# DRAINAGE LETTER

## LOT 11, ROLLING THUNDER BUSINESS PARK

April 2, 2021

County File No.: PPR-21-24

# DRAINAGE PLAN

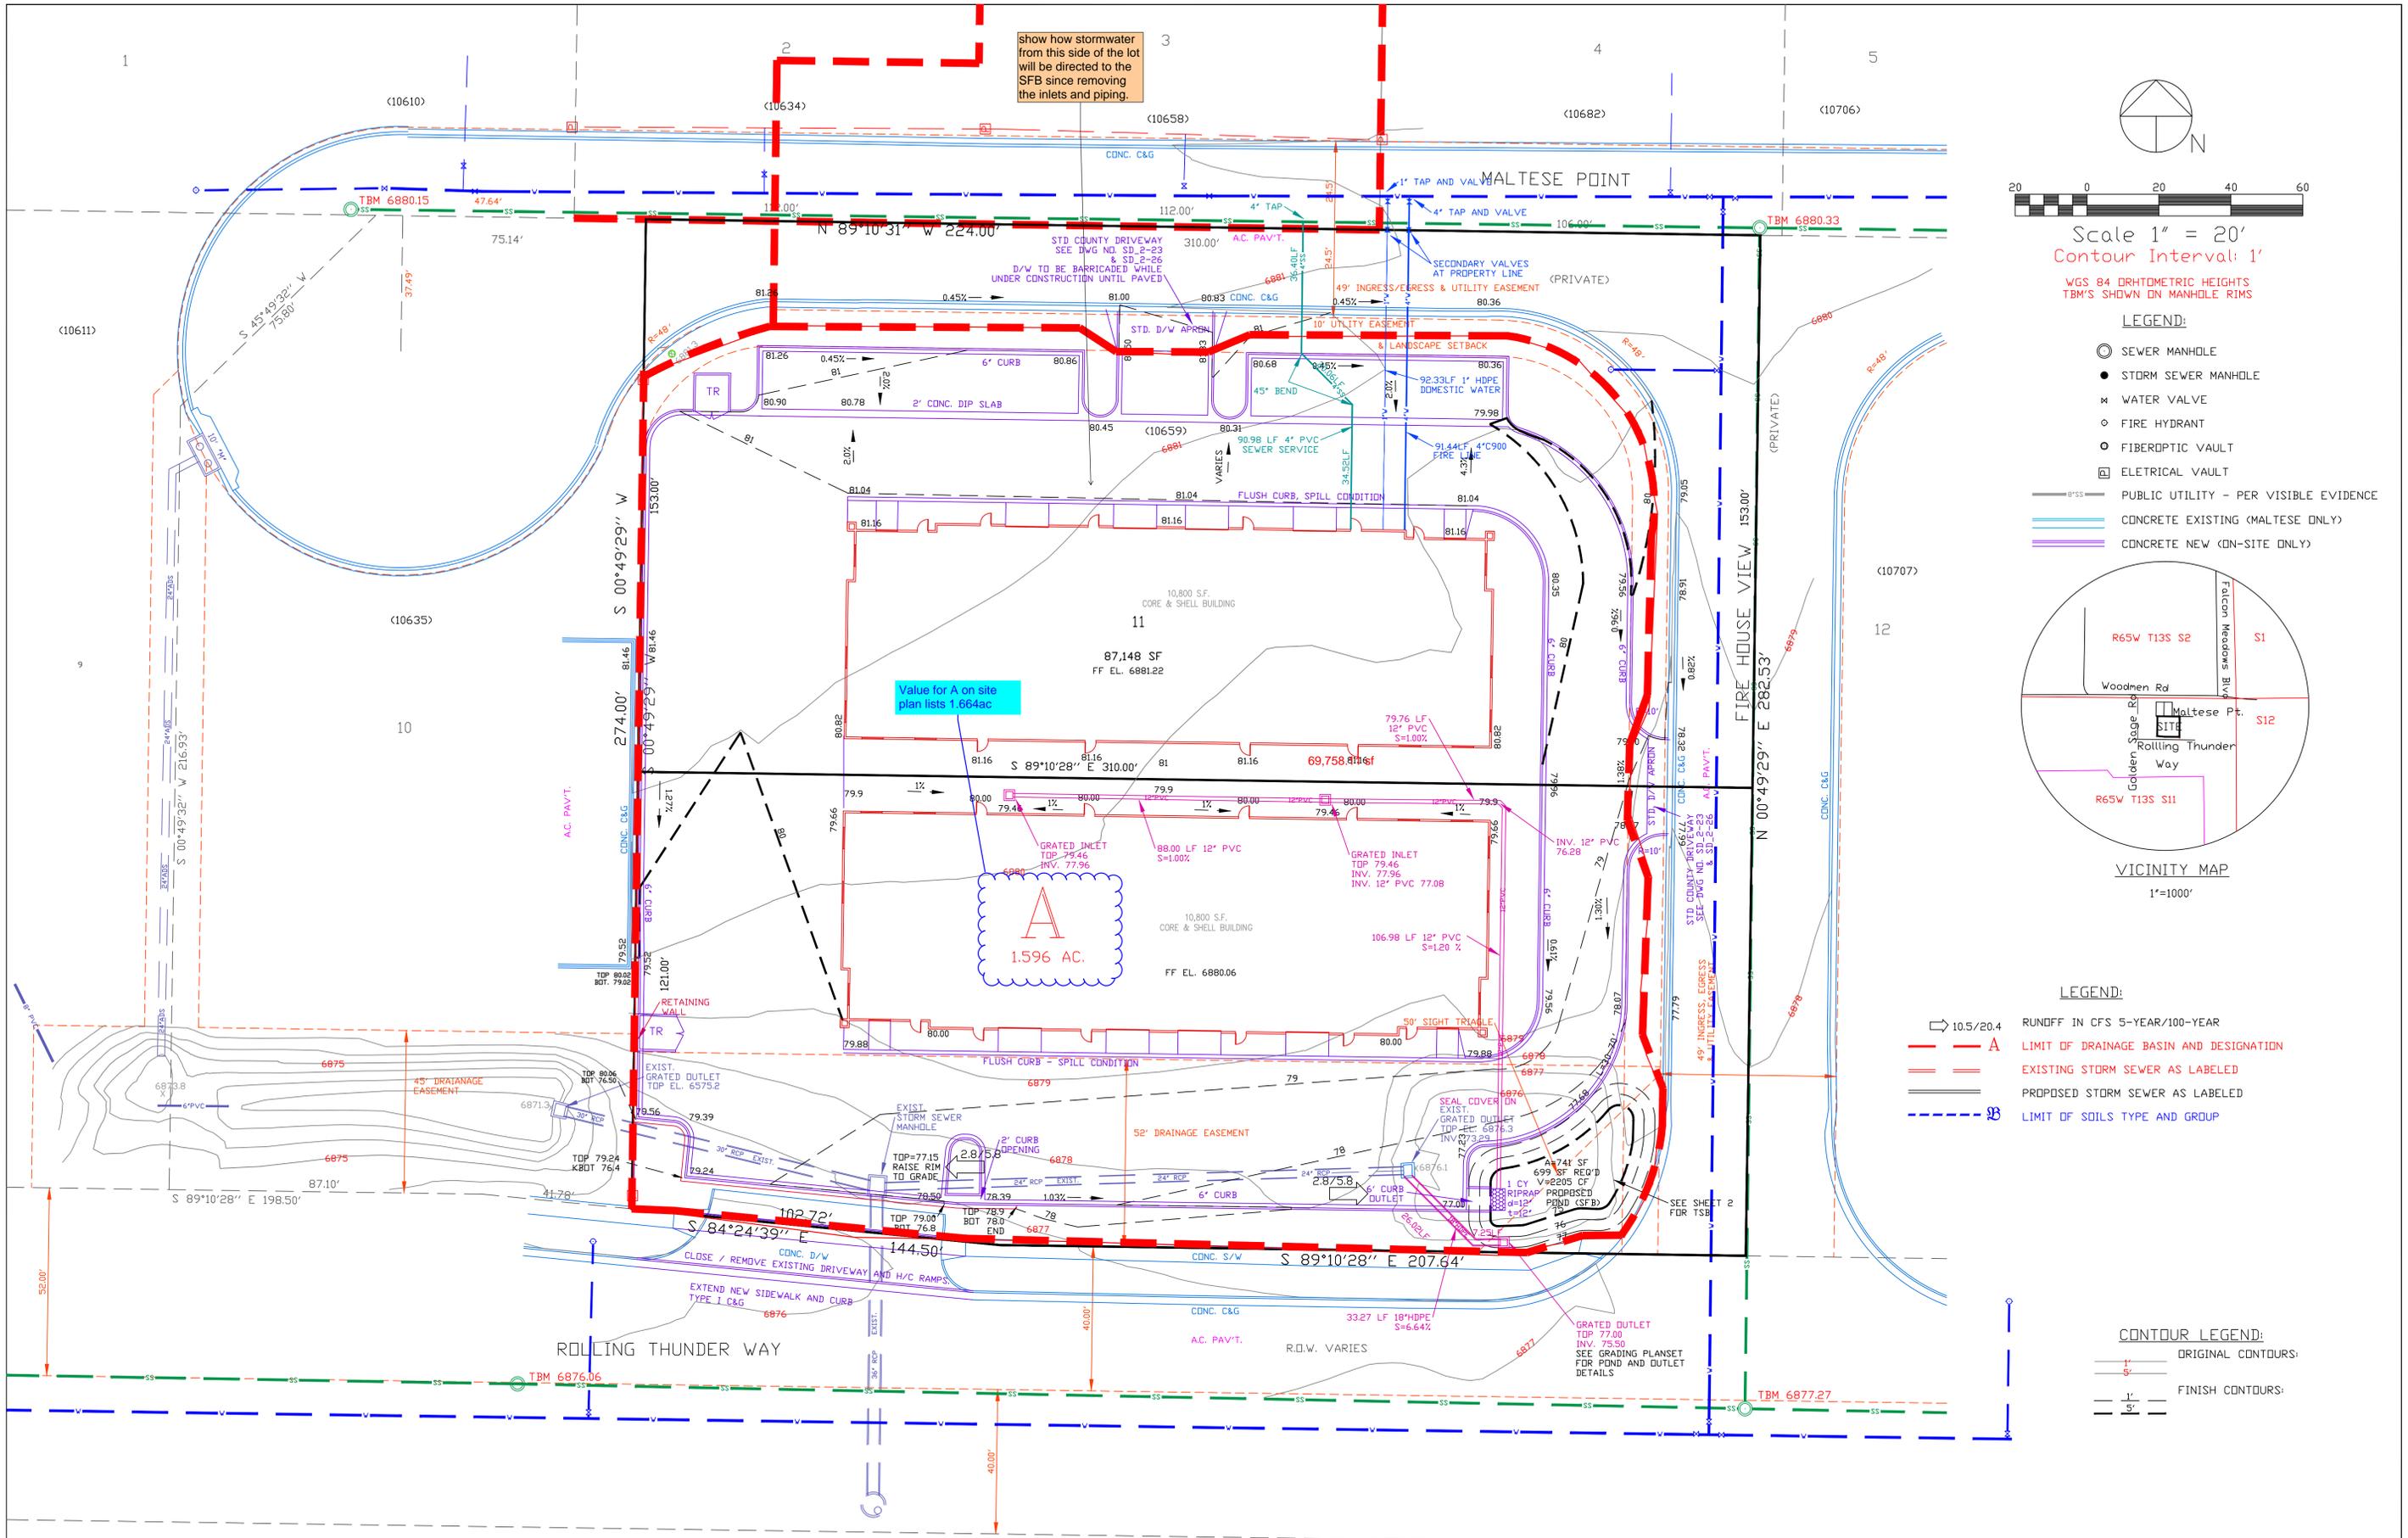
This area is larger than the basin area "A" on the site plan or your developed area on page 5 above
